**SUBJECT: FINAL TRIP REPORT—DECOMMISSIONING INSPECTION OF THE  
HOMESTAKE MINING COMPANY OF CALIFORNIA, GRANTS, NEW  
MEXICO (RFTA NO. 96-16)**

**TRIP REPORT  
DECOMMISSIONING INSPECTION OF THE  
HOMESTAKE MINING COMPANY OF CALIFORNIA  
GRANTS, NEW MEXICO**

FIGURE 6: Area D84033 – Measurement and Sampling Locations

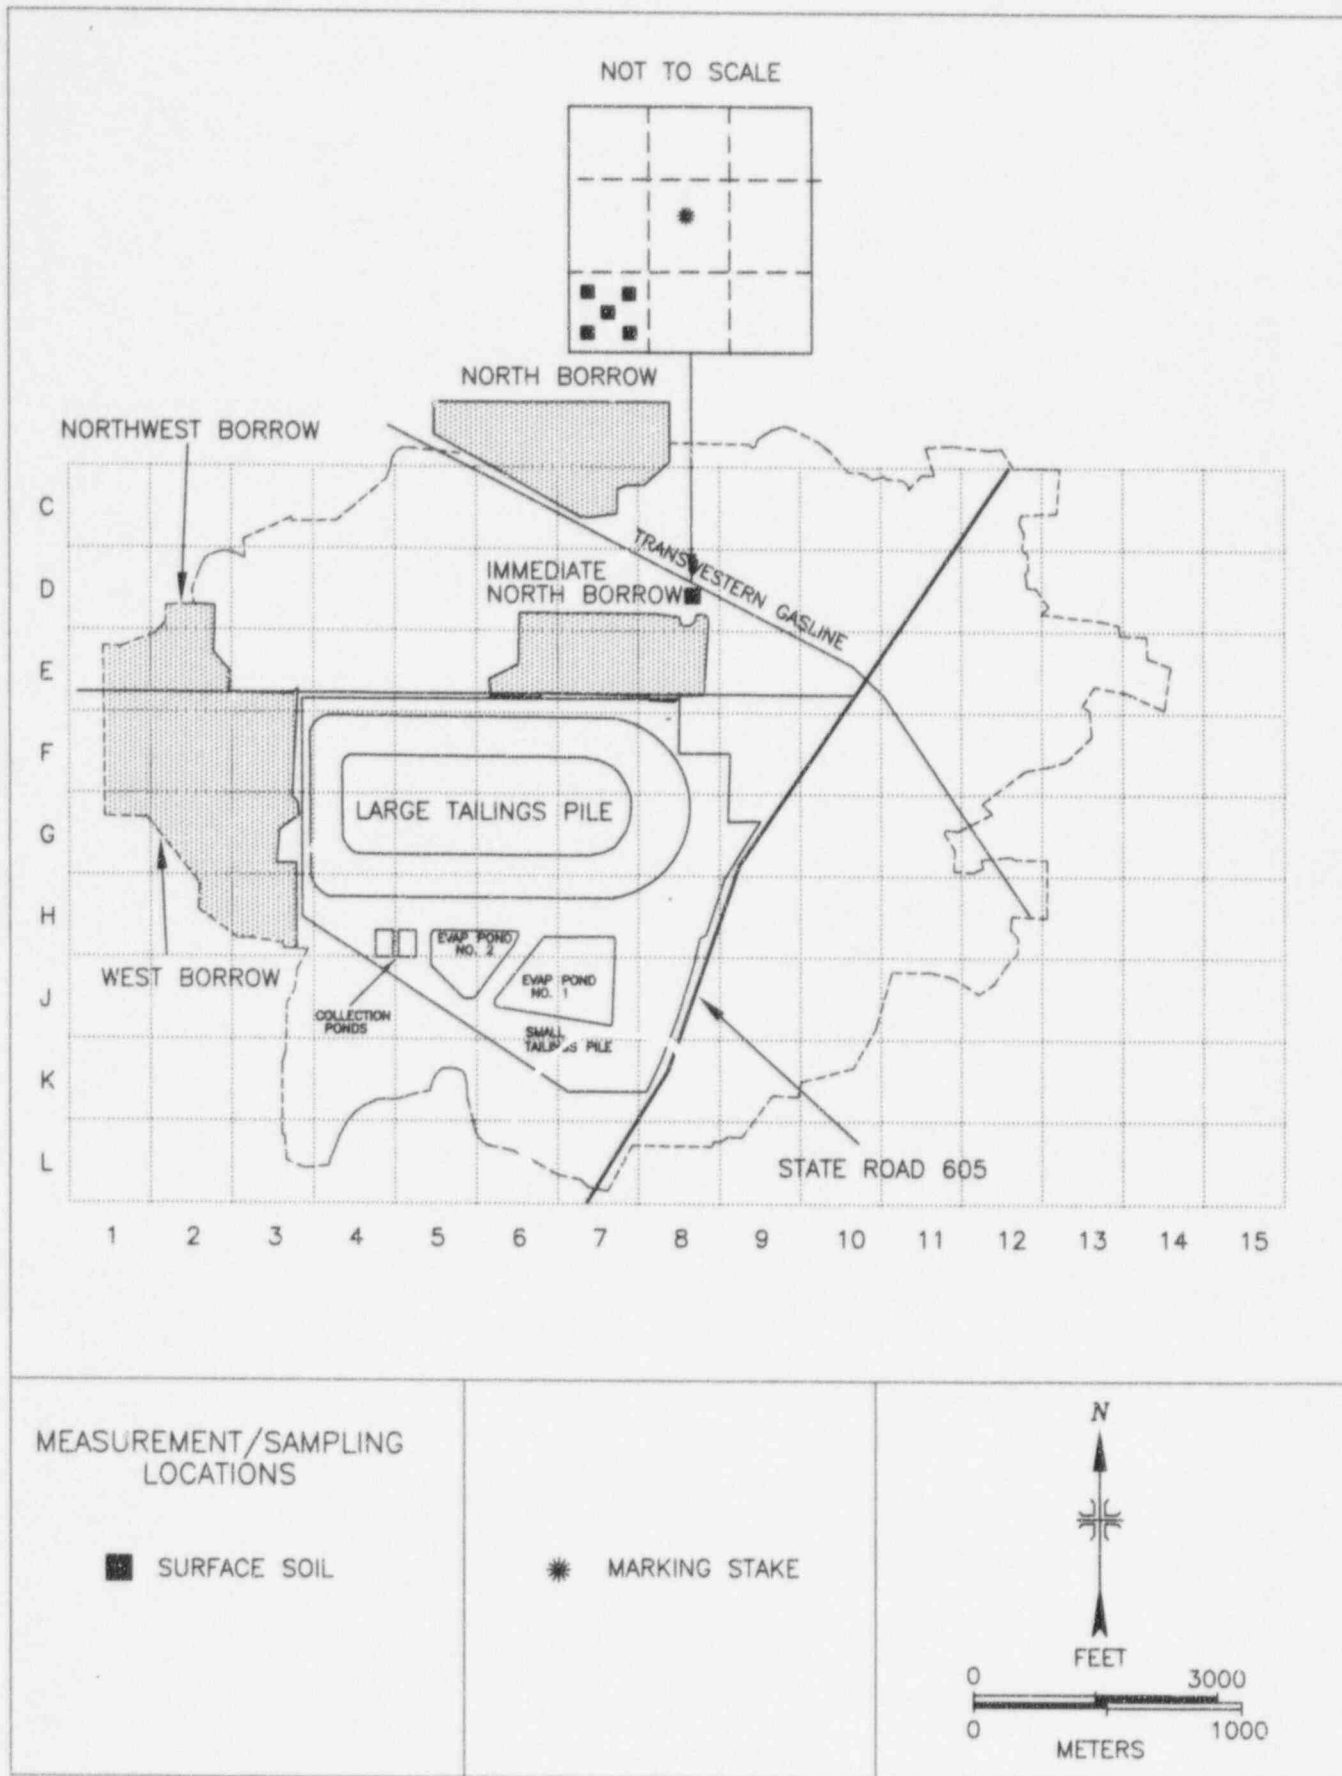
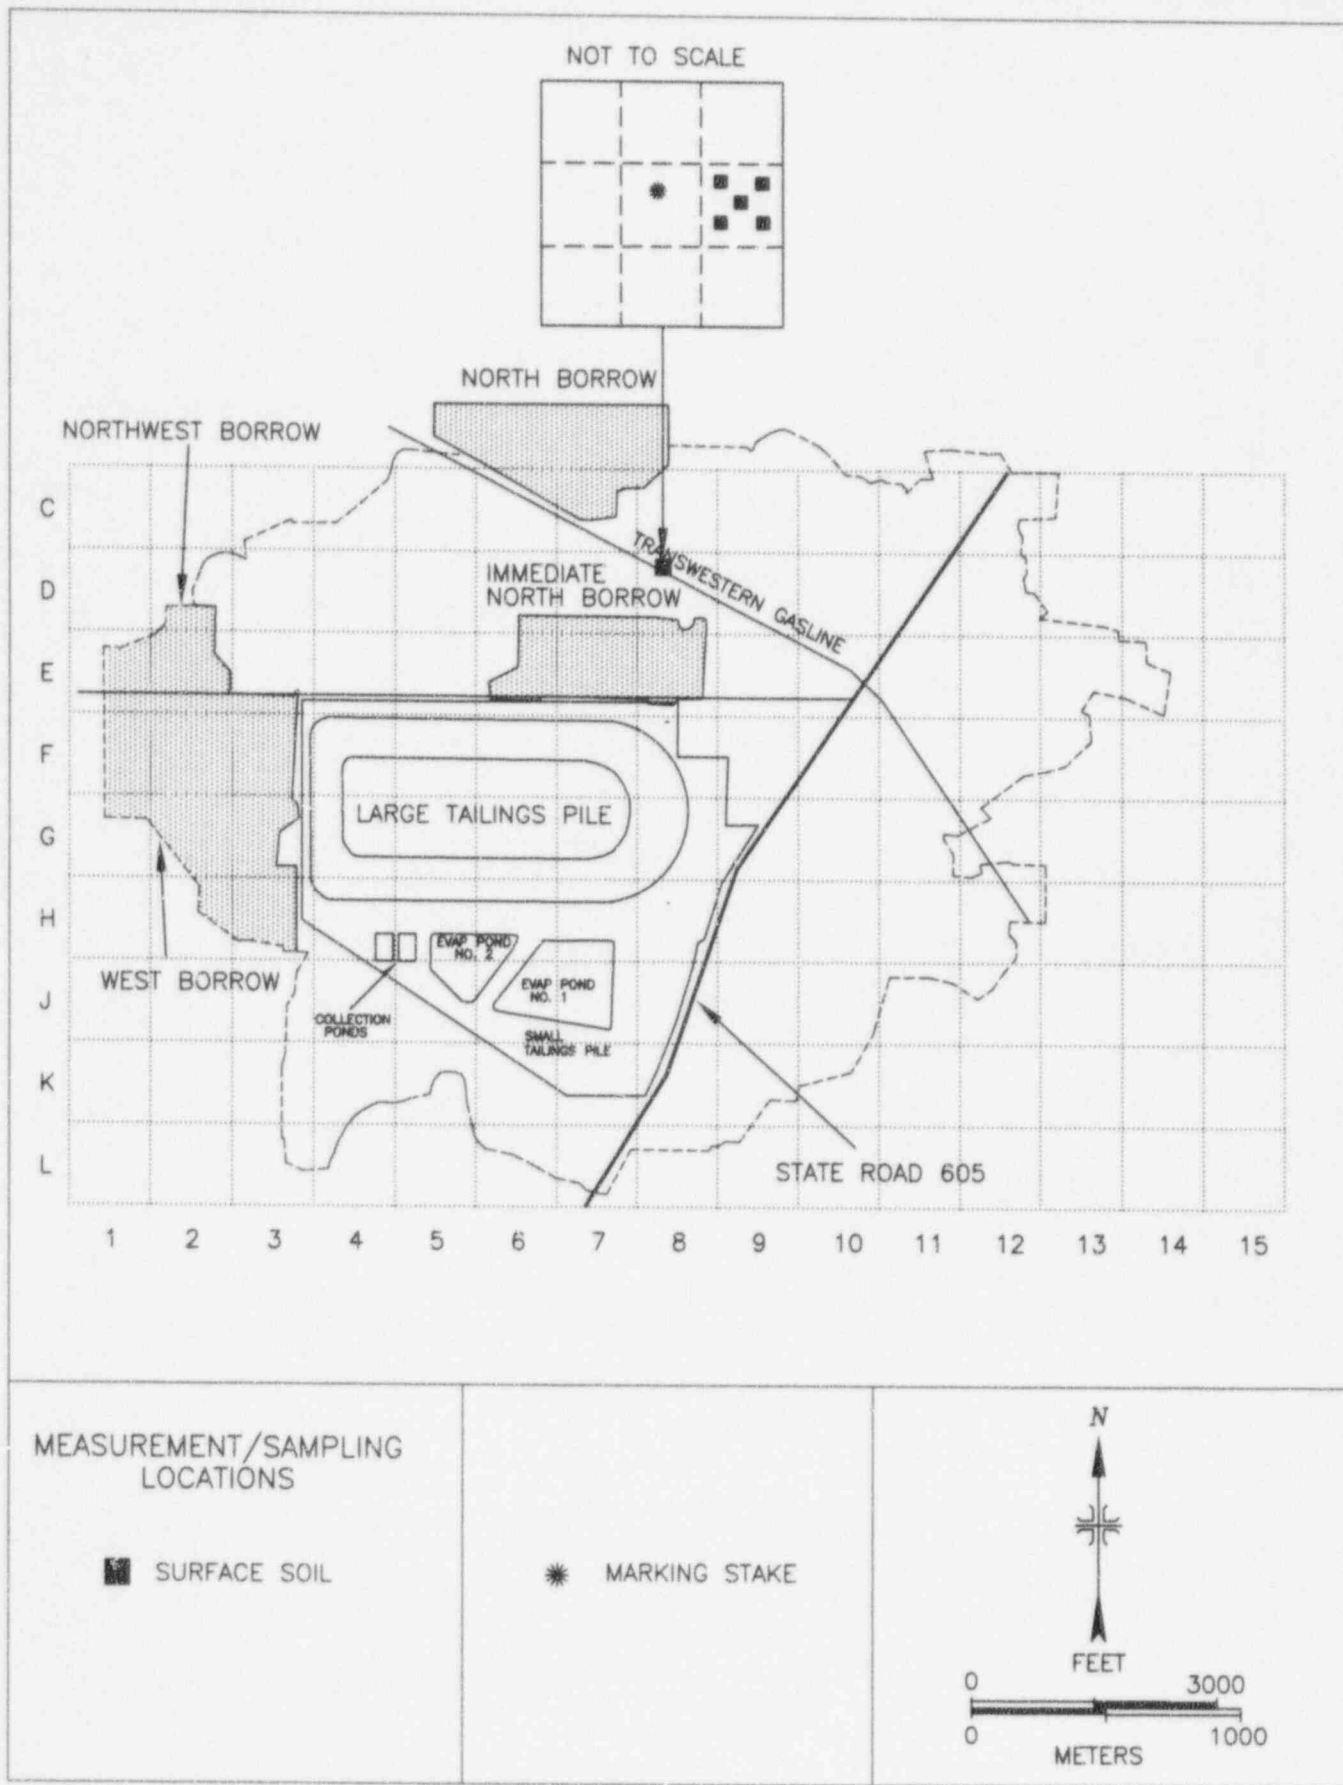
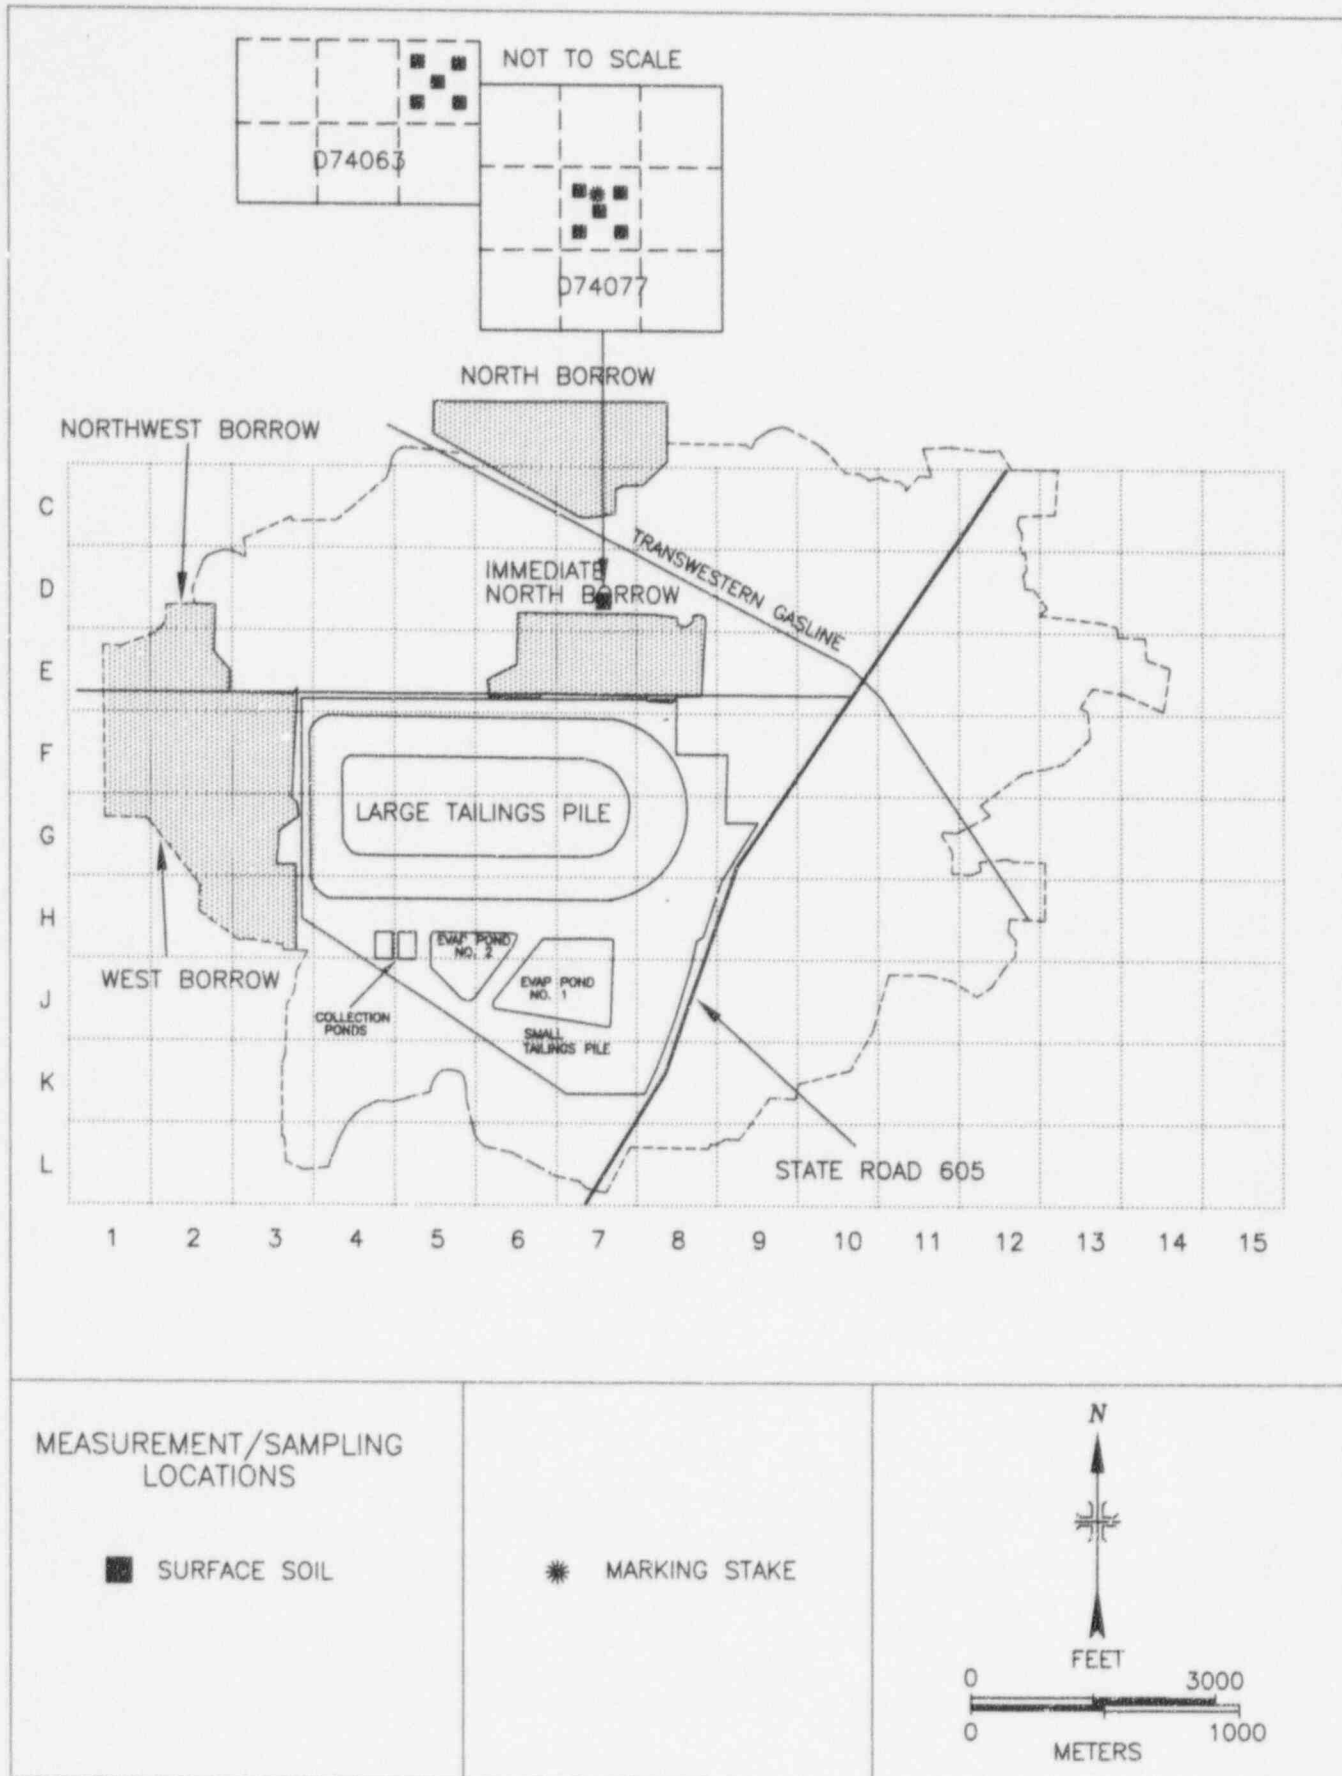
- 6.4 Perform gamma readings with a  $\mu$ R meter at random and suspect locations, in windblown areas and on cell covers.
- ESSAP performed gamma surface scans over seven 900 m<sup>2</sup> areas—selected on the basis of the licensee's data indicating potential anomalies—within the Outer Zone (Figures 1 through 9) and seven areas within the buffer zone and  $\mu$ R/h measurements were performed at 40 locations within the Outer Zone. These measurements are provided in Table 1. No measurements were made on the pile covers.

Gamma scans identified a number of locations of elevated direct radiation within surveyed areas from which ESSAP collected composite samples from the 100 m<sup>2</sup> area associated with each anomaly (a total of eight samples were collected from the seven surveyed areas). These samples were processed by the licensee and split samples prepared for confirmatory gamma spectrometry analysis by the licensee and ESSAP. The licensee was requested to collect a sample from an eighth area identified within the buffer zone. An additional sample was collected by the licensee and provided to ESSAP for analysis on November 7, 1996.
